# New Catherine Field Primary School Modification 1

State Significant Development Modification Assessment (SSD-9477-MOD-1)

October 2020

**Figure 6 | Proposed revised layout (Source: Applicant's Modification Application 2020)**

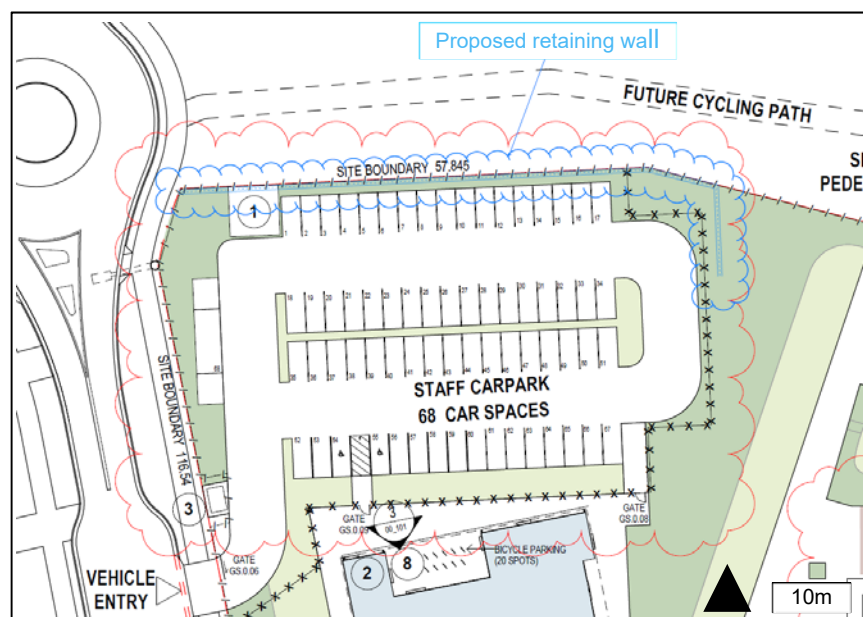
- that it did not object to the proposed operational readiness work subject to the controls proposed by the Applicant and the provision of on-site parking arrangements.
- the retaining wall should be revised to be consistent with the location of the wall as depicted in the further revised site plan submitted in SSD-9477-Mod-2.
- details of the material of the wall should be provided. Sandstone was recommended.
- a balustrade may be needed at the top of the wall depending on its height to comply with the Building Code of Australia.
- a standard condition of consent should be imposed requiring the retaining wall to comply with standard design requirements as follows:

- any discrepancies between plans submitted Mod-1 and Mod-2 can be resolved prior to determination of Mod-2.

- on-site parking for operational readiness work is not possible given construction works continue on site. However, alternative arrangements are proposed to avoid impacts on the local road network, including for staff to park at nearby schools with shared transport to the site.
- the layout of the retaining wall proposed in SSD-9477-Mod-2 will be reviewed to ensure that it reflects the layout intended.
- the retaining wall would be made of blockwork given that the wall is intended to be temporary visible.
- it is expected that a balustrade would not be required as the land to the north of the site is expected to be developed (and the level change removed) prior to completion of the car park.
- the proposal would comply with the requirements of the condition recommended by Council.

- revision of the approved plans listed in condition A2 to incorporate the revised site plan and elevation of the retaining wall.
- inclusion of Council's recommended condition as revised above to omit the requirement for graffiti protection.
- inclusion of a condition requiring graffiti to be removed within 24 hours.
- inclusion of a condition requiring the wall to be painted and graffiti protection be applied if the wall remained exposed six months after the commencement of operation.

**Figure 7 I Proposed retaining wall elevation (Source: Applicant's Modification Application 2020)**

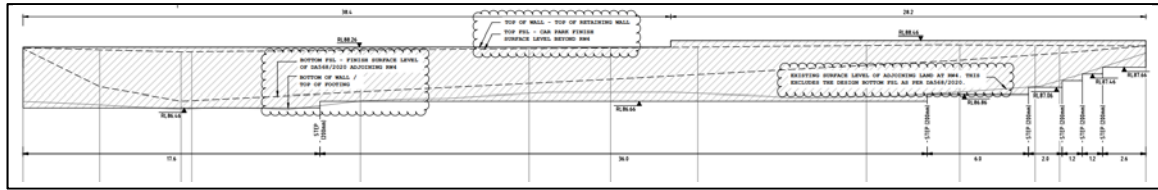
- the use of blockwork for the wall is appropriate given that it will only be visible on a short-term basis. A recommended condition of consent requires the wall to be painted if proposals for the land to the north of the wall were to change such that the wall would be permanently visible.

- Council's recommended condition is accepted except for the requirement for graffiti protection given the cost of doing so and the expected short-term exposure of the wall. Instead, a condition has been recommended that graffiti be removed with 24 hours and that graffiti protection be provided if proposals for the land to the north of the wall were to change such that the wall would be permanently exposed.
